BIDDING ADDENDUM NO. 1

**CATAWBA COUNTY CATTLEMEN'S ASSOCIATION
EDUCATION CENTER
NEWTON, NORTH CAROLINA
CBSA Project 2024.008
August 24, 2026**

1 WALL DETAIL
A6.0 SCALE: 3/4" = 1'-0"

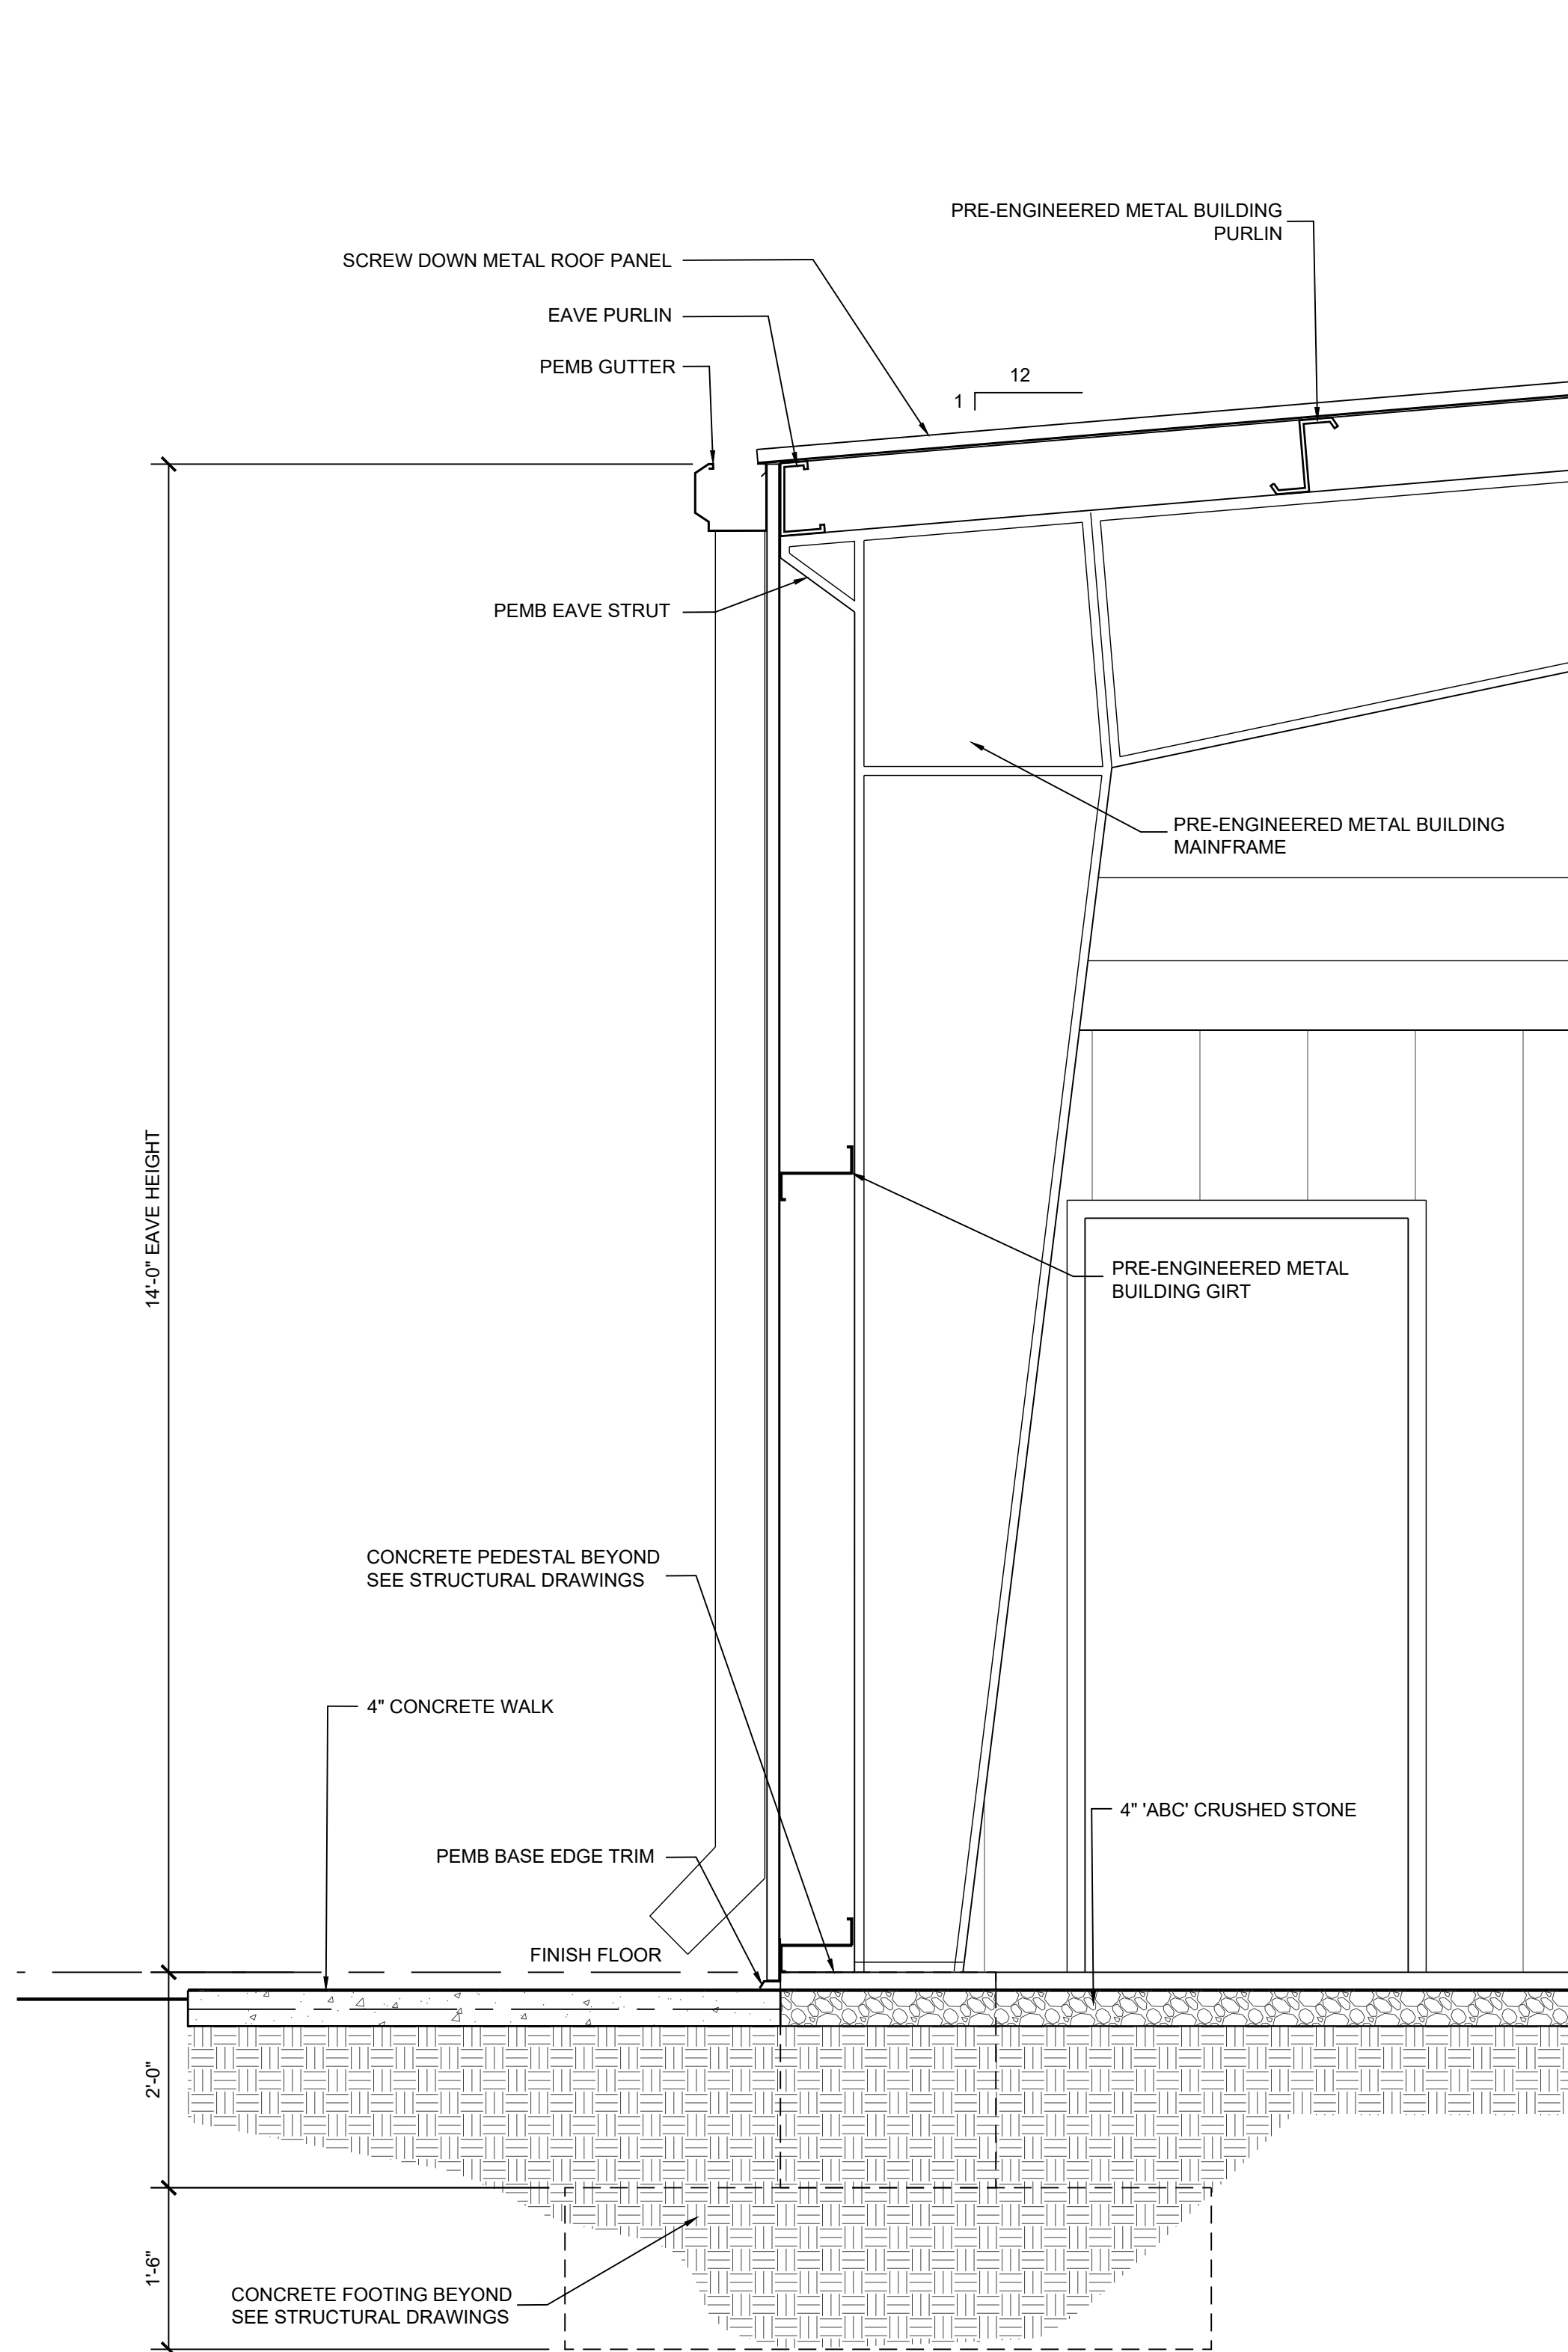
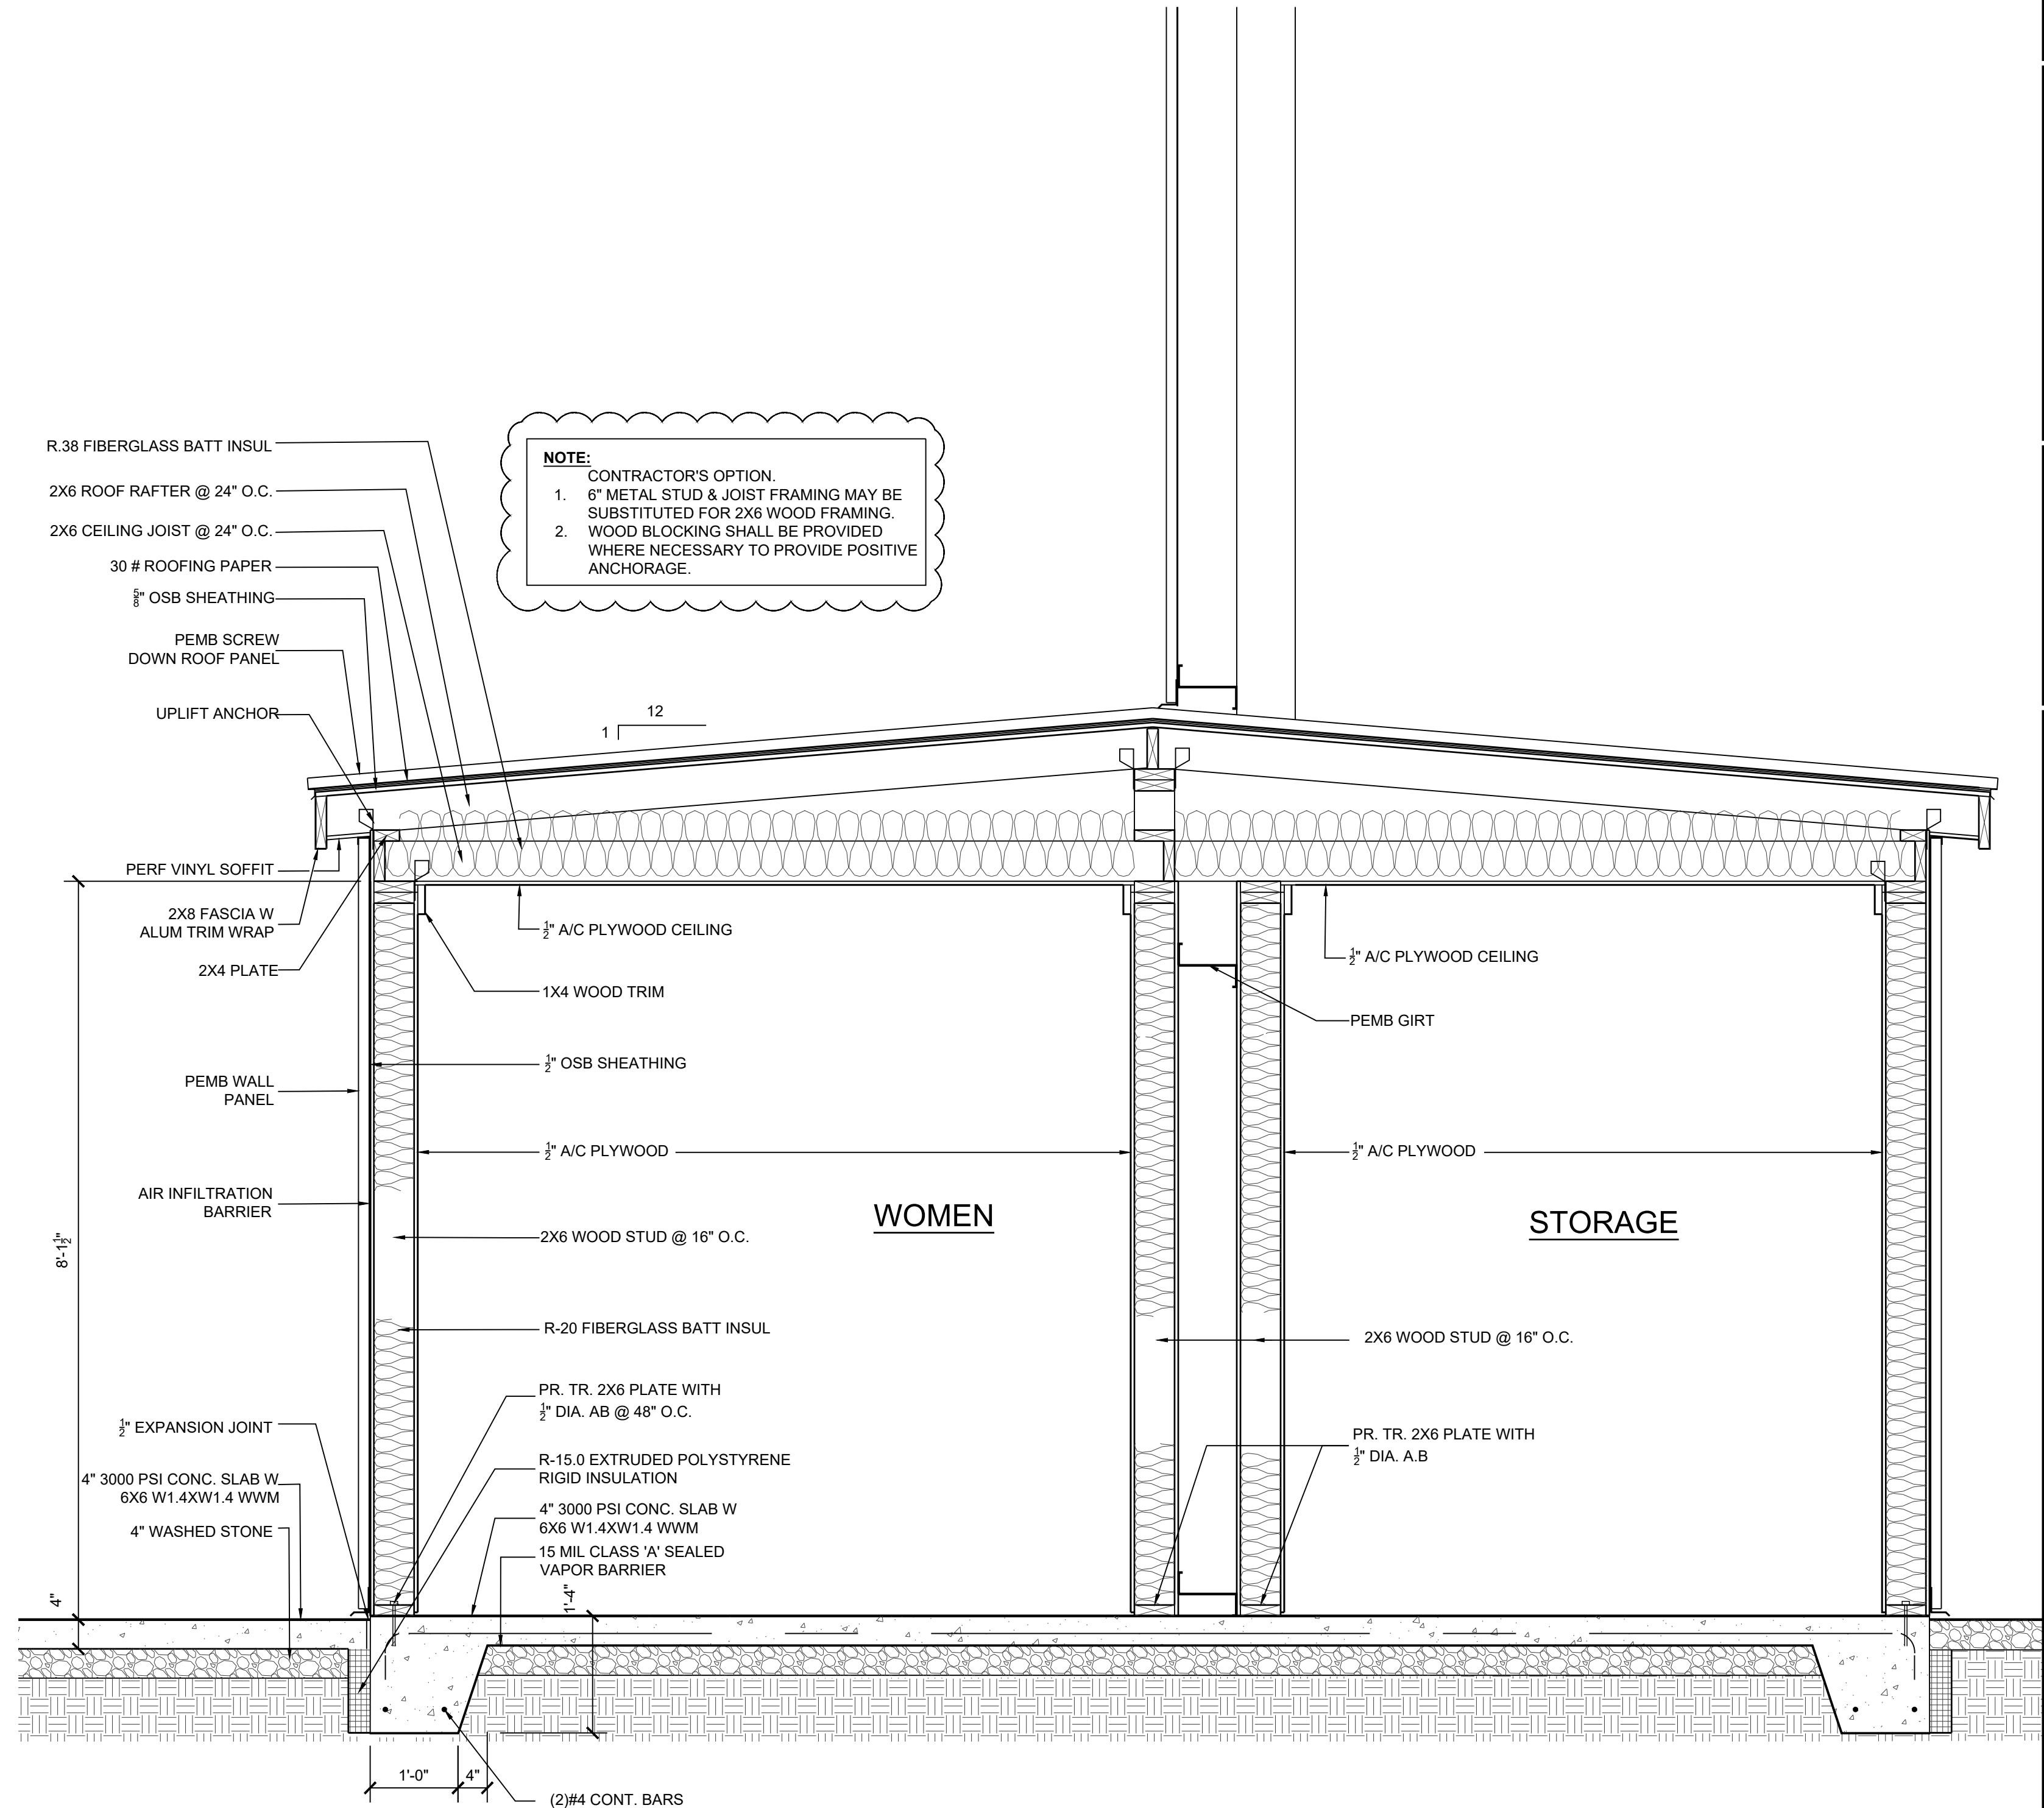
14. Contractor option to substitute metal framing for wood framing. See attached drawing.

FLOOR PLAN - POWER

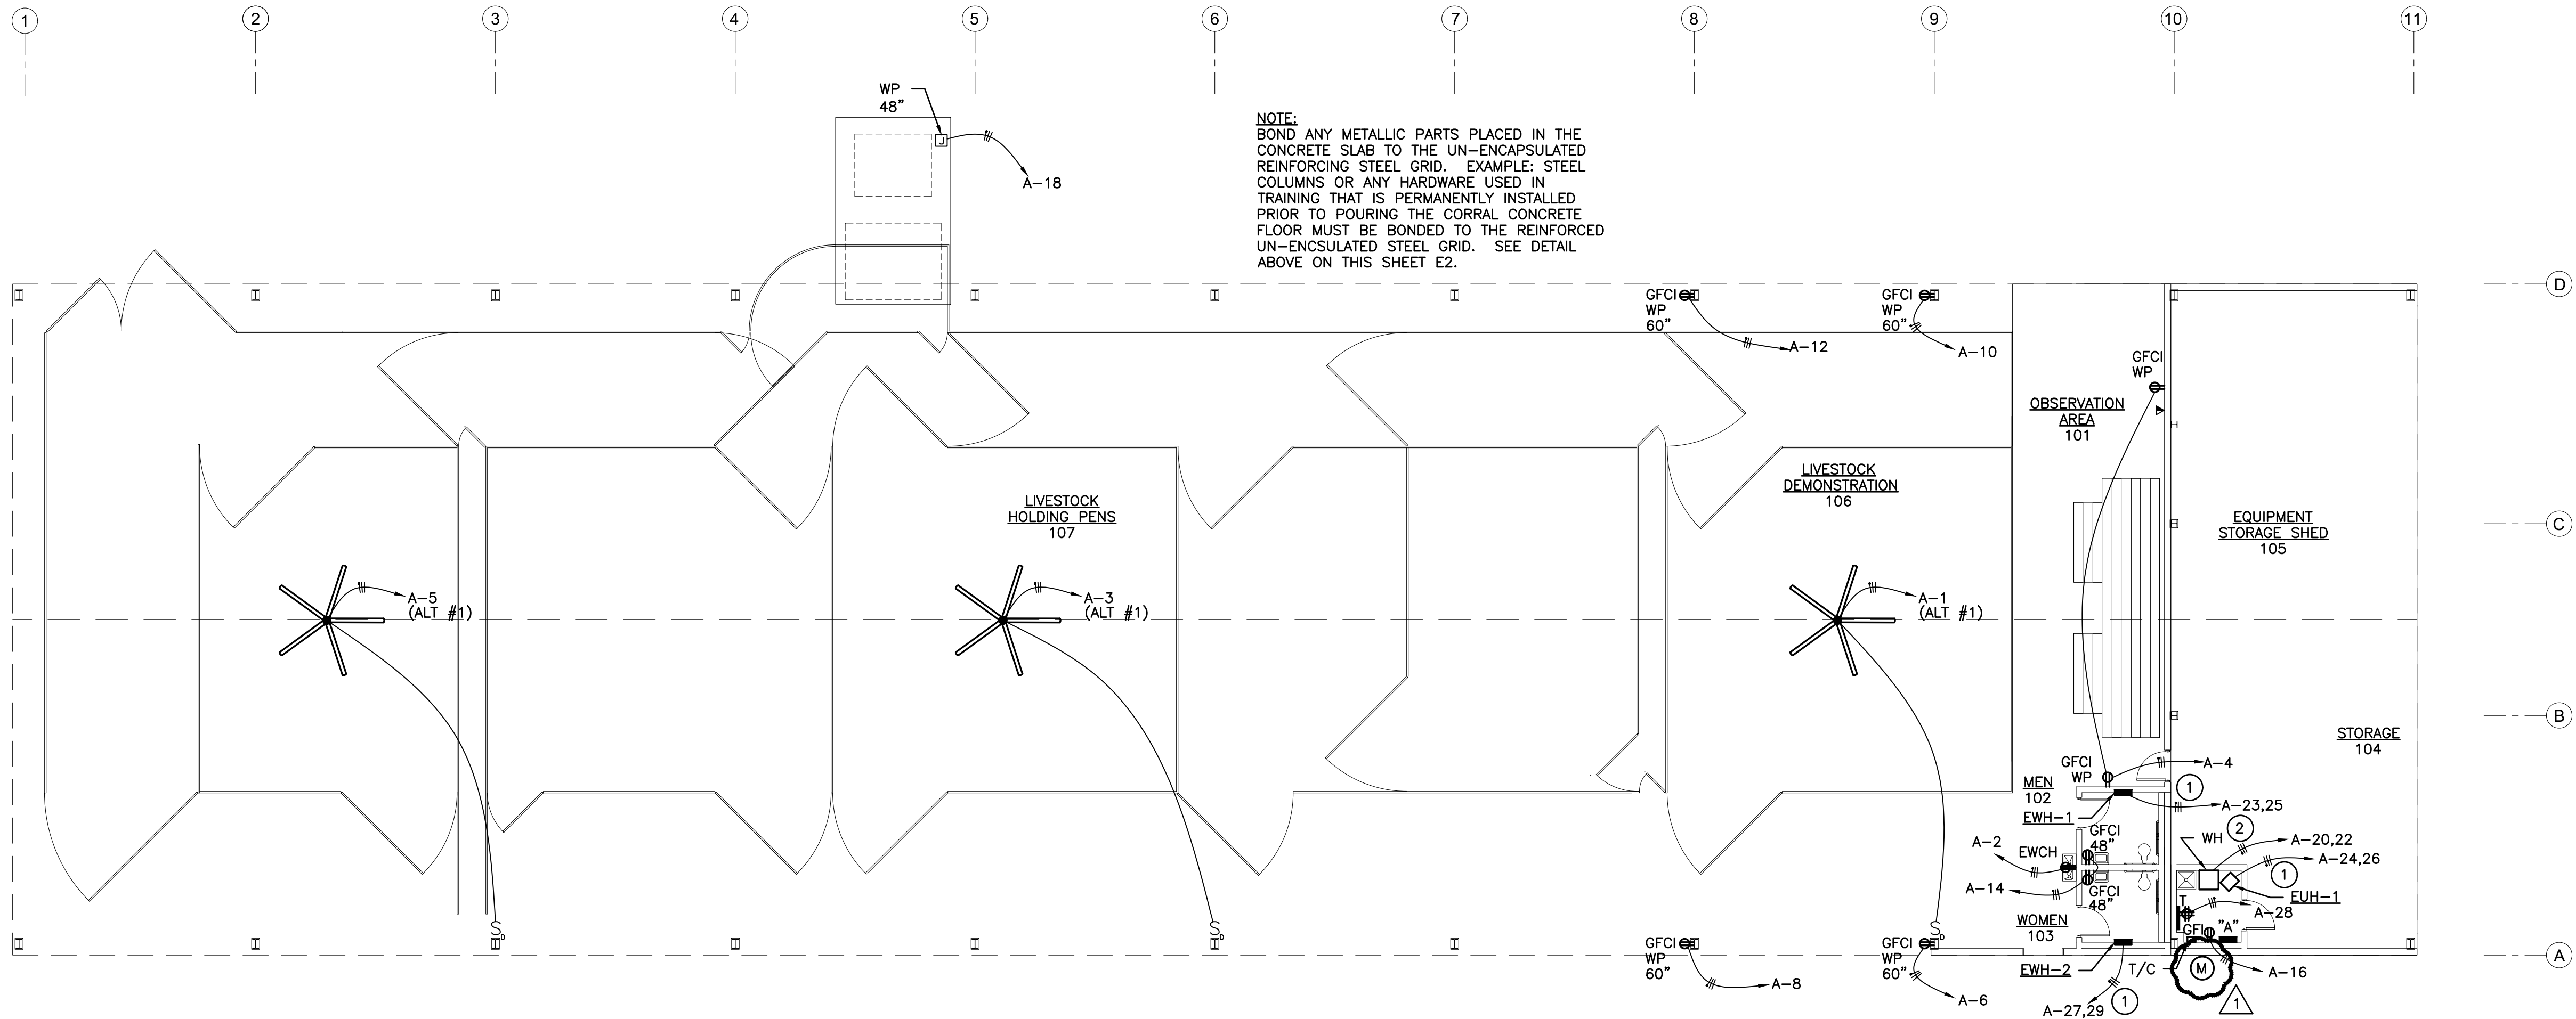
15. Meter base by power provider is located opposite side of exterior wall from Panel A. See attached drawing.
